Addendum No. 2

Project: Fort Wayne International Airport
Construct Taxiway G Extension & Demolish Taxiway C2
AIP No. 3-18-0022-XX

Date: June 20, 2024

Drawing No.: **C4.2.1**

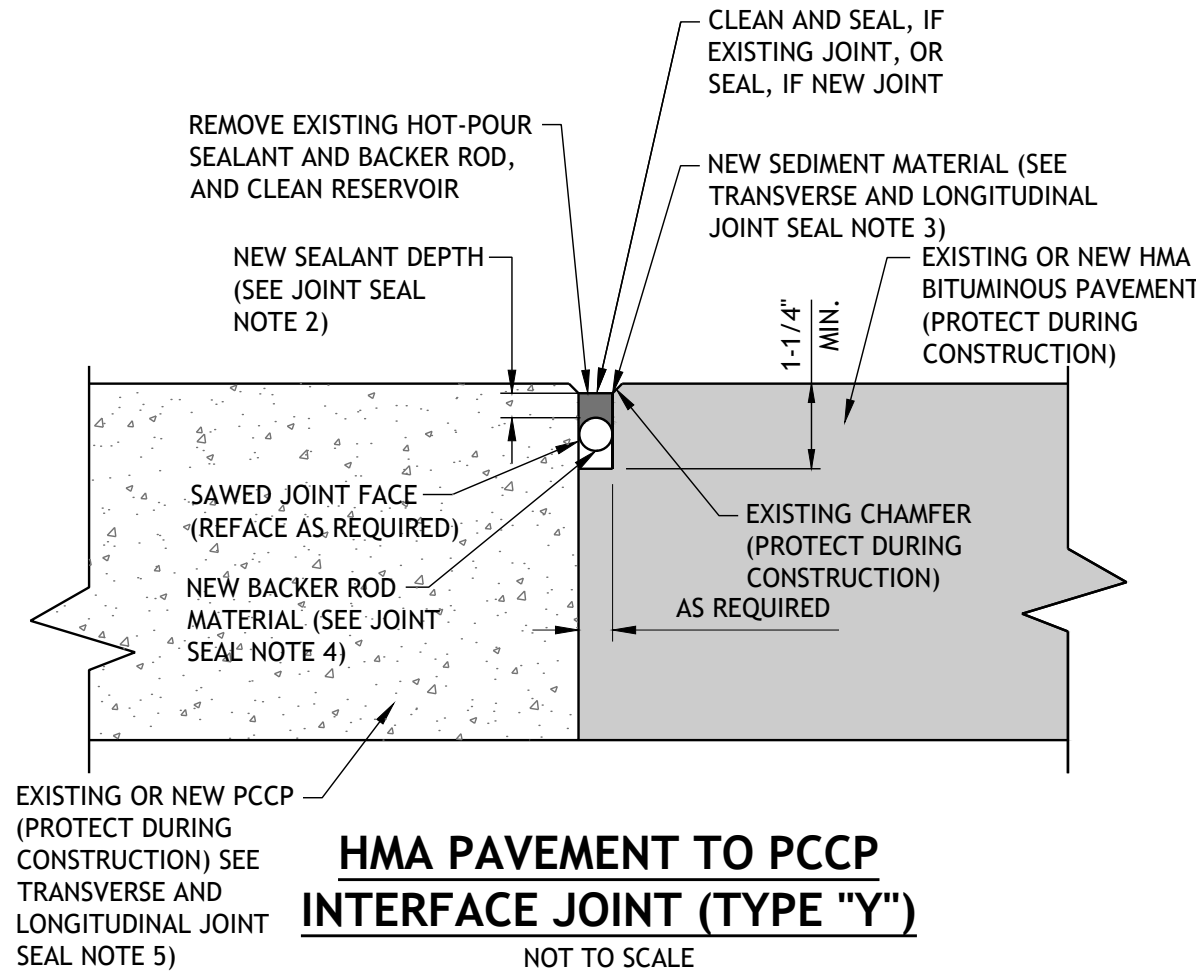
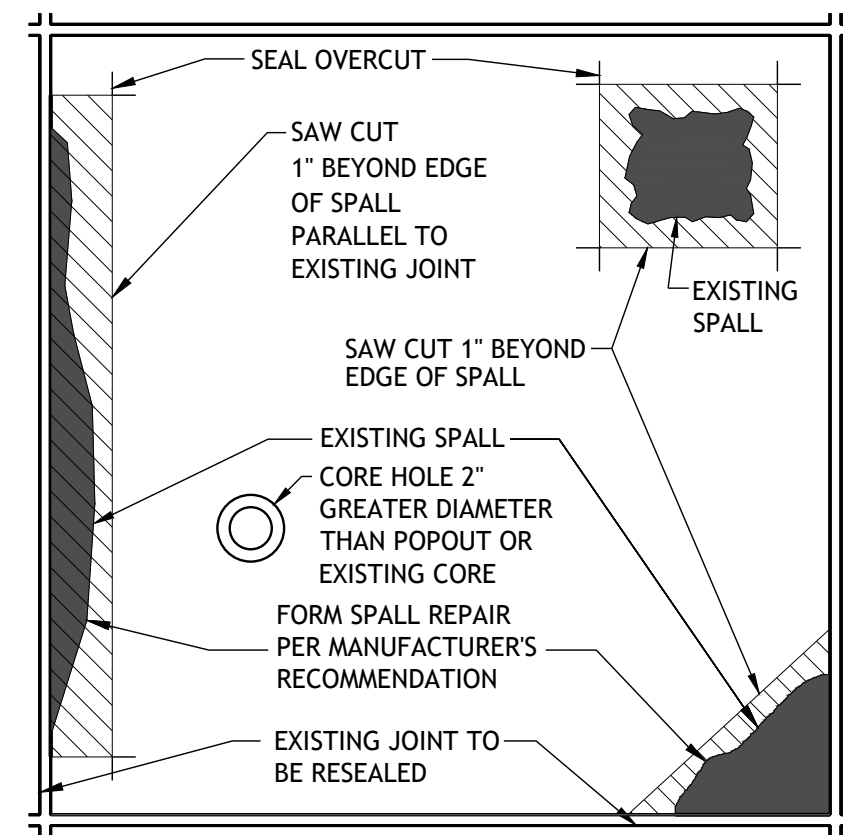
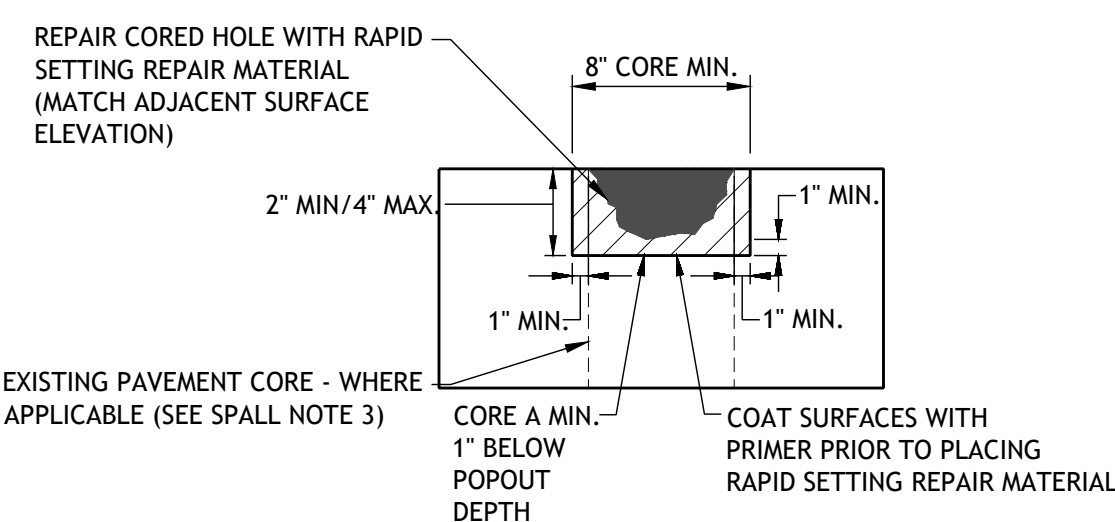
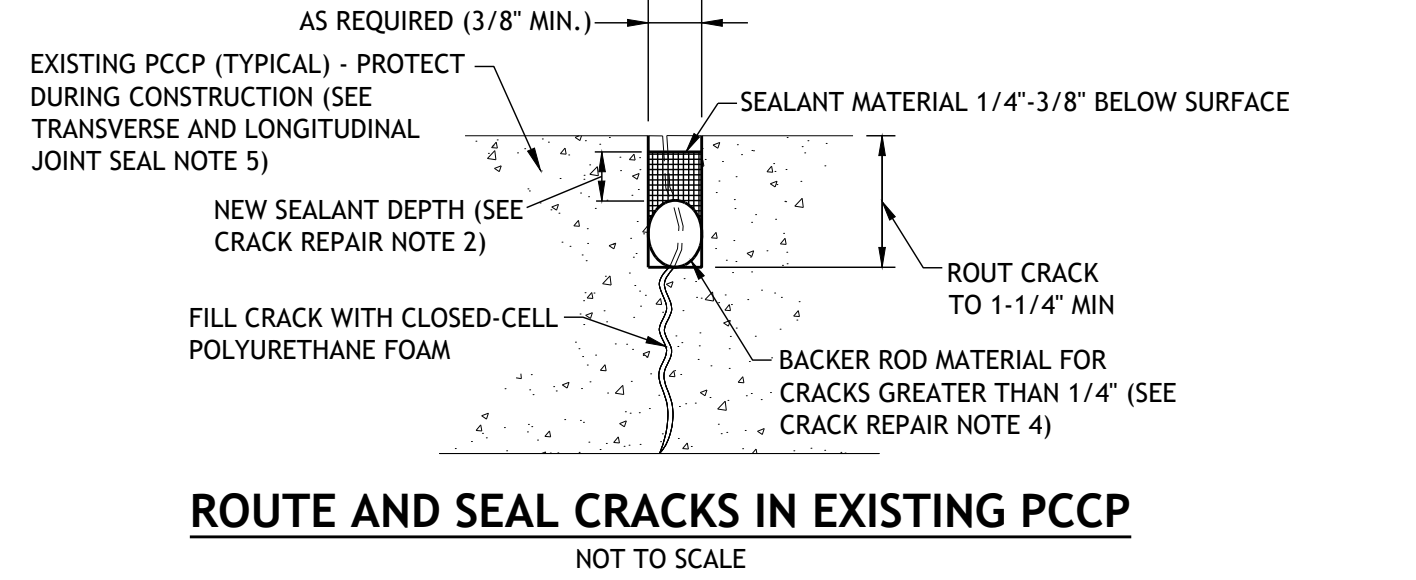
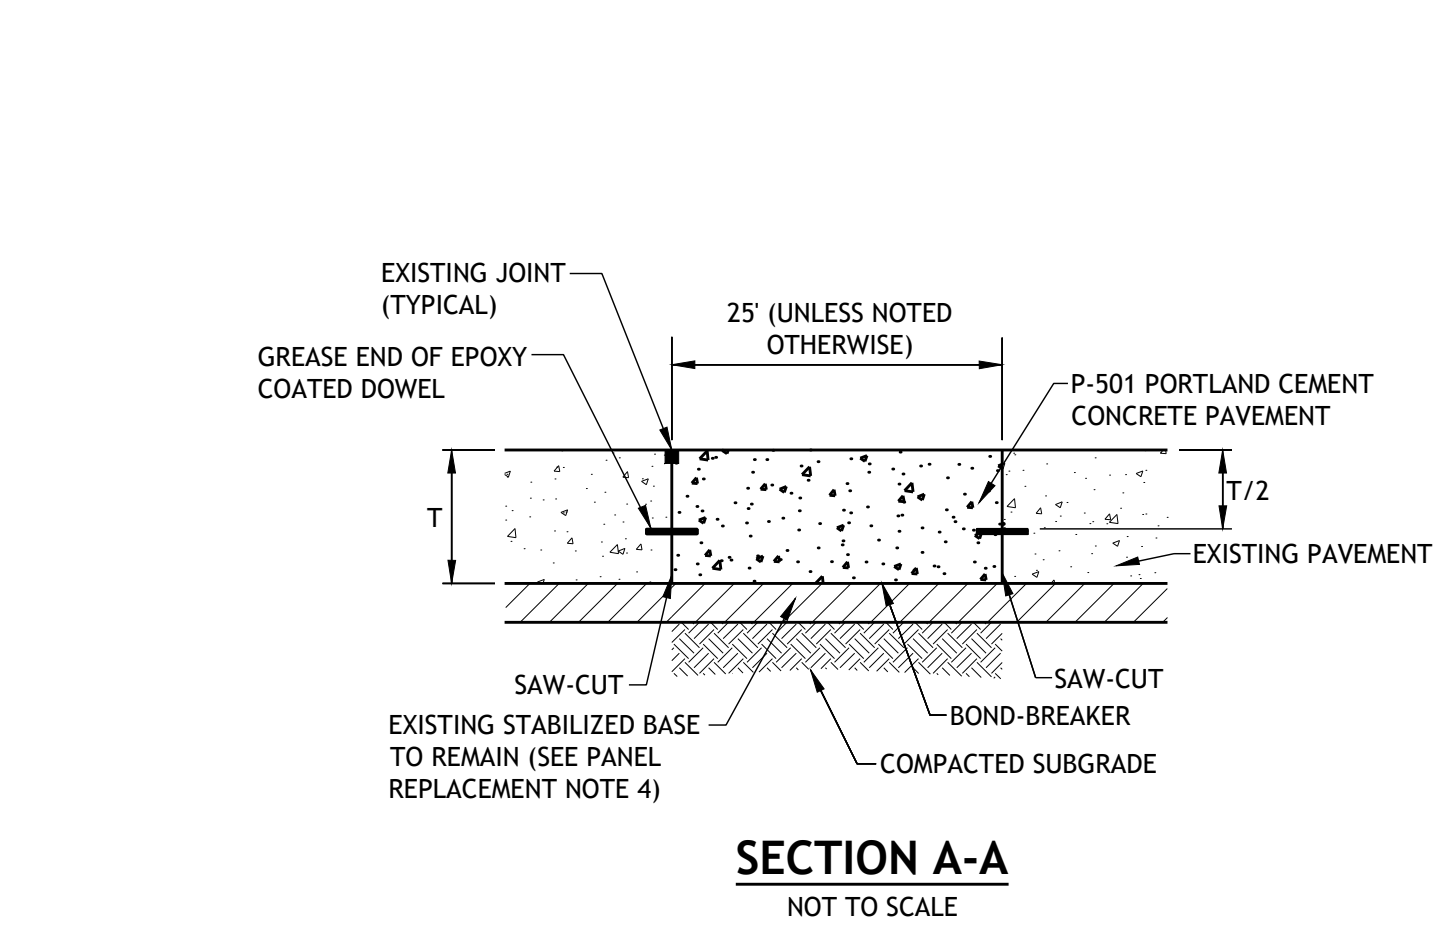
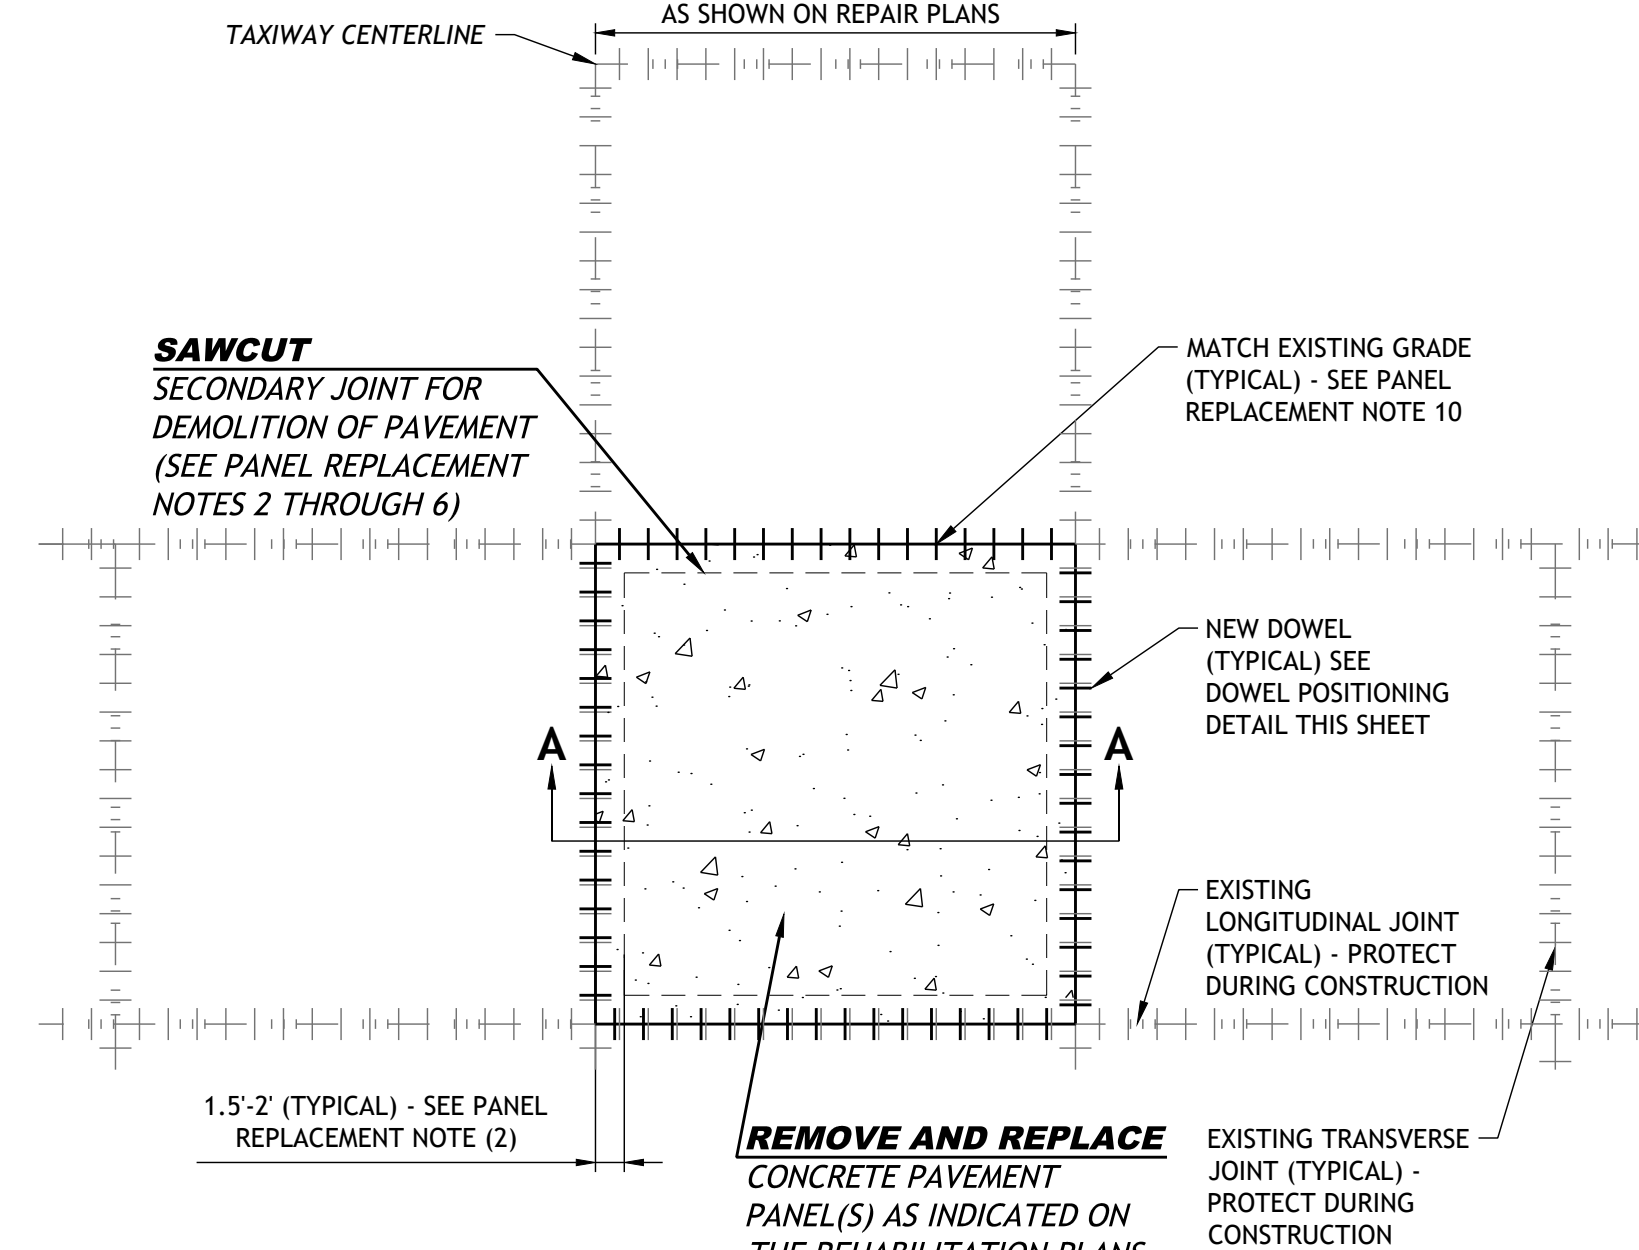
Issued: New sheet has been added to reflect proposed pavement repair details to coincide with new sheets C2.1.1 and C2.1.2 for work required on Taxiway C between the West Apron and Runway 14-32.
